# REGIONAL REVIEW NOTIFICATION

DATE: March 5, 2018 ARC REVIEW CODE: R1803052

Name of Proposal: McDonough Commerce Center II

### MCDONOUGH COMMERCE CENTER II DRI Henry County Natural Resources Group Review Comments

# DRI SUBMITTAL PLAN

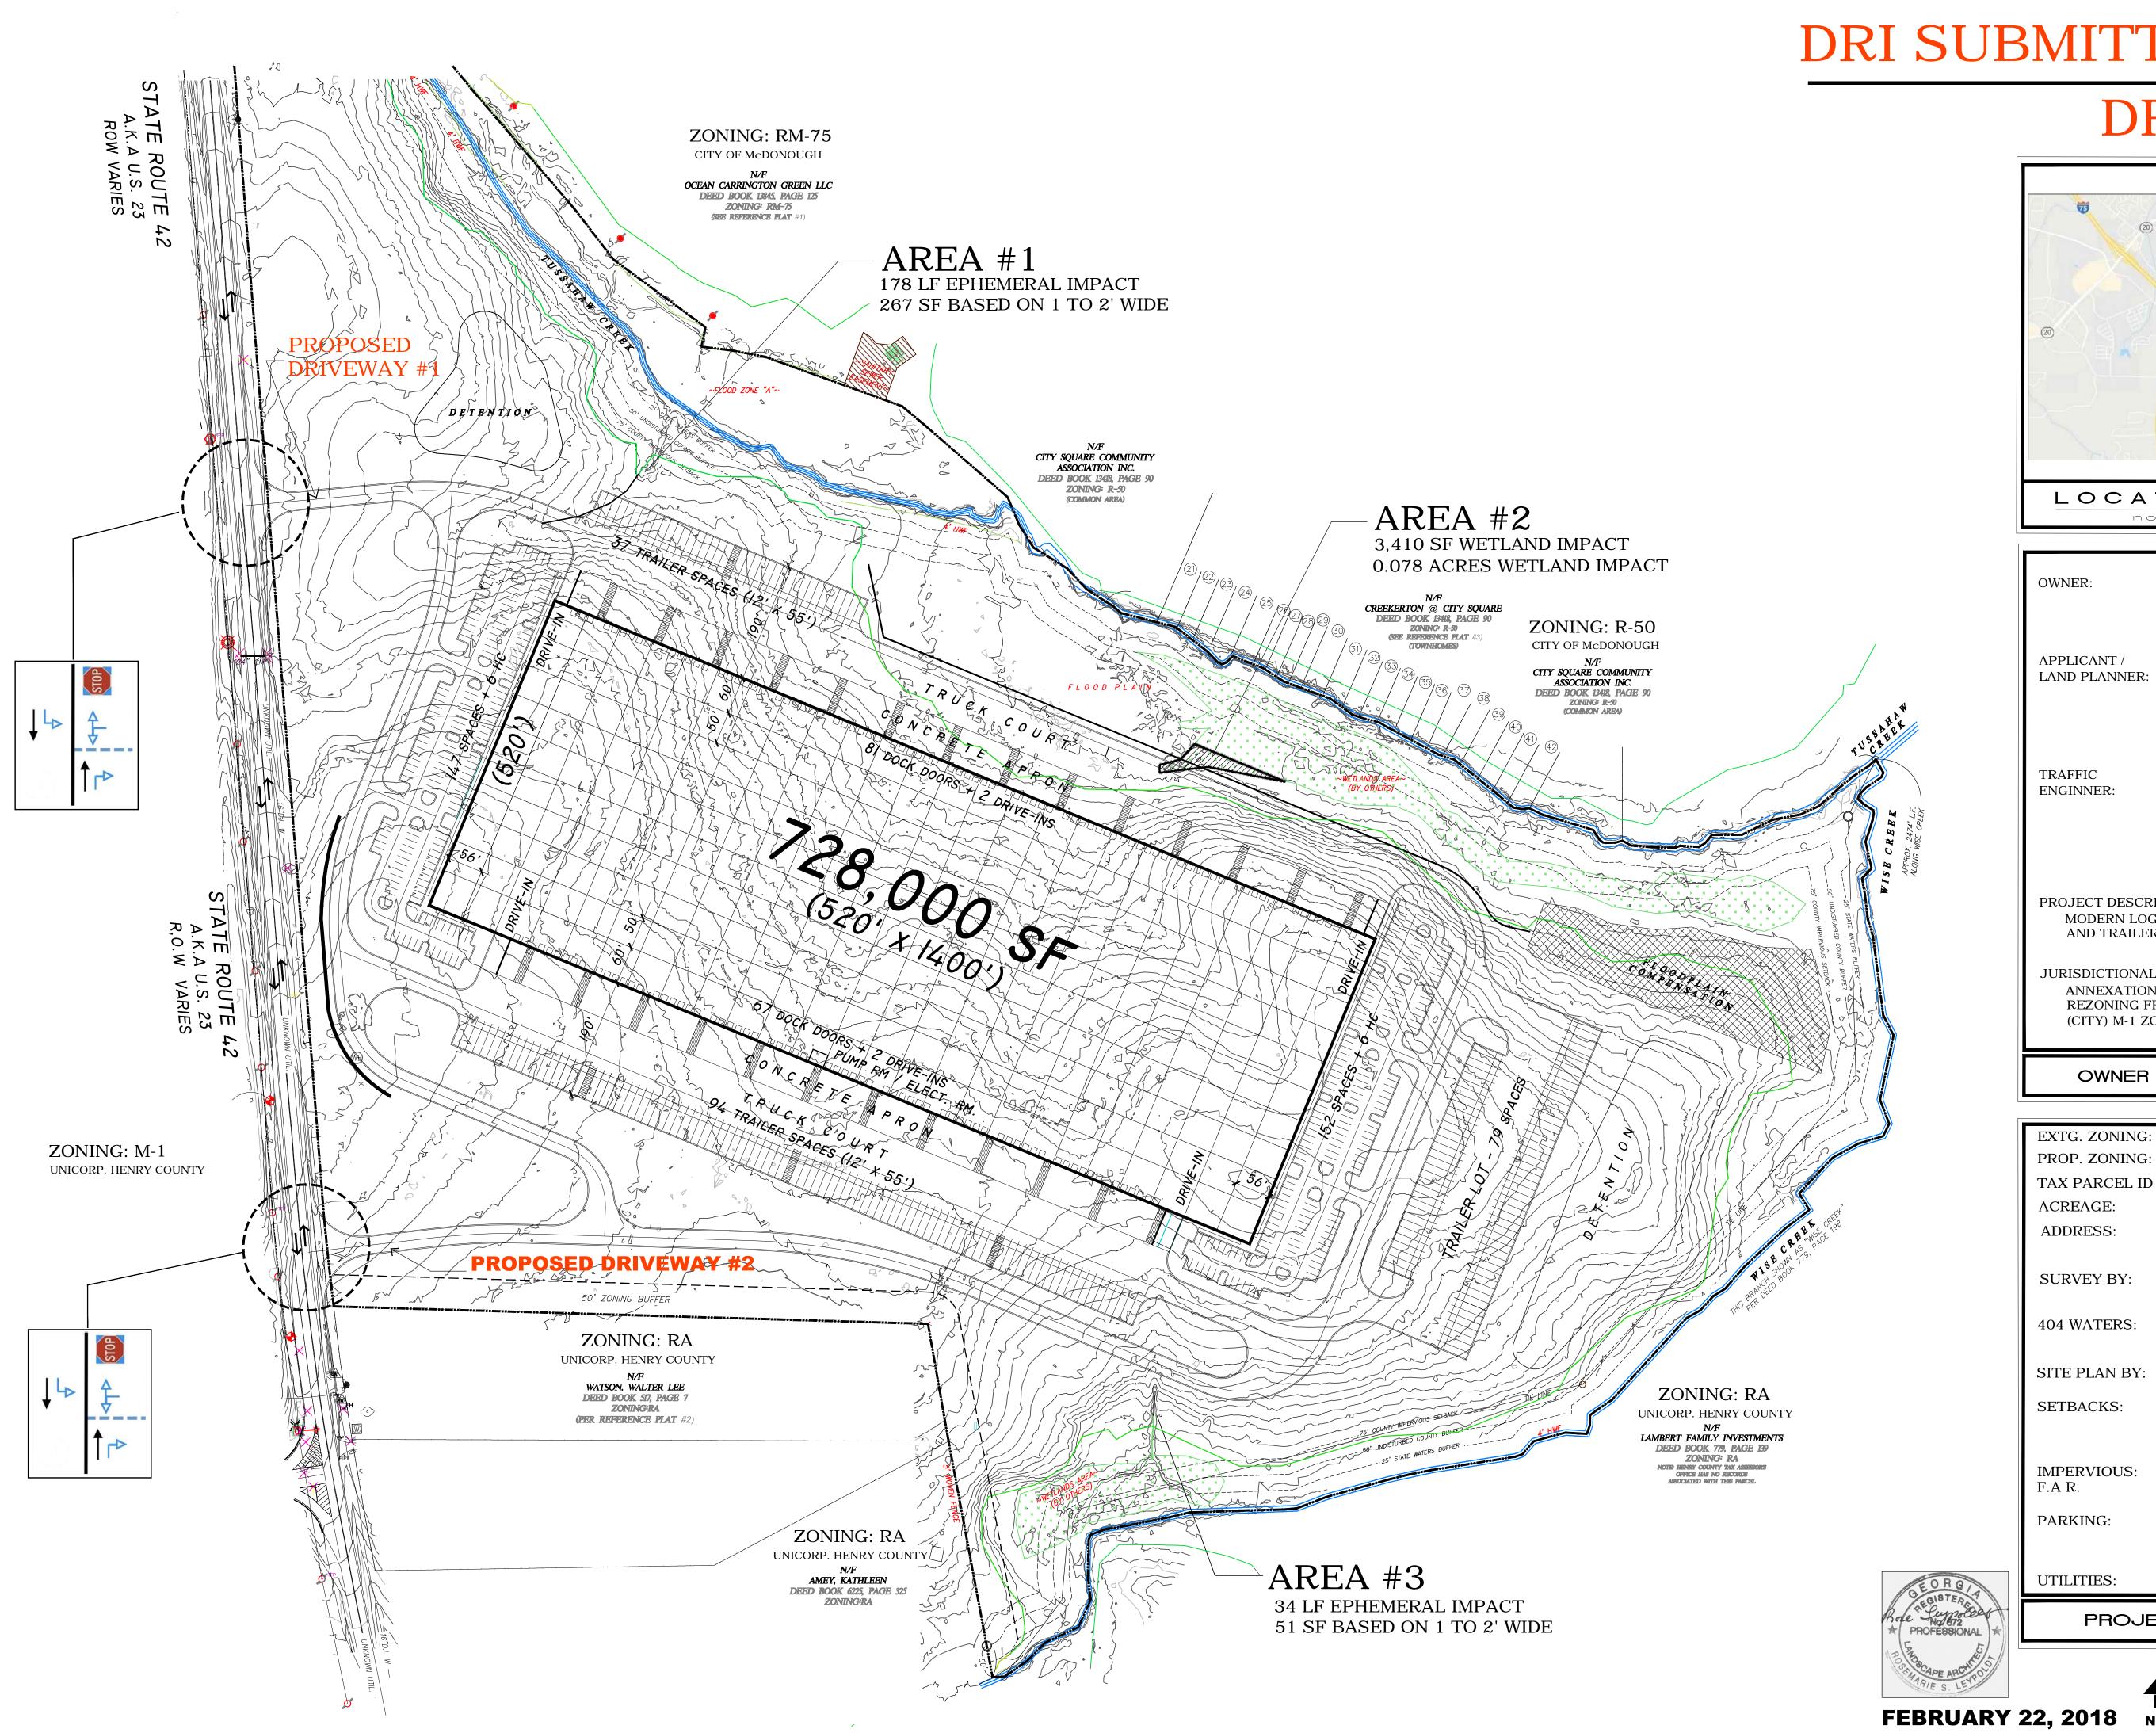
The submitted site plan shows that the property is bounded by Tussahaw Creek on the north side of the property and Wise Creek, a tributary to Tussahaw, on the south and east sides of the property. No other perennial or intermittent streams are shown on the project site plan, and no other blue-line streams are shown on or near the property on the USGS coverage for the project area. The site plan shows on both streams the 50-foot undisturbed buffer and 75-foot impervious surface setback required by the Henry County's Stream Buffer Ordinance, as well as the 25-foot State Erosion and Sedimentation Act buffer. Any unmapped streams on the property may also be subject to the County buffers. Any other waters of the state on the property will be subject to the 25-foot State Erosion and Sedimentation Act buffer.
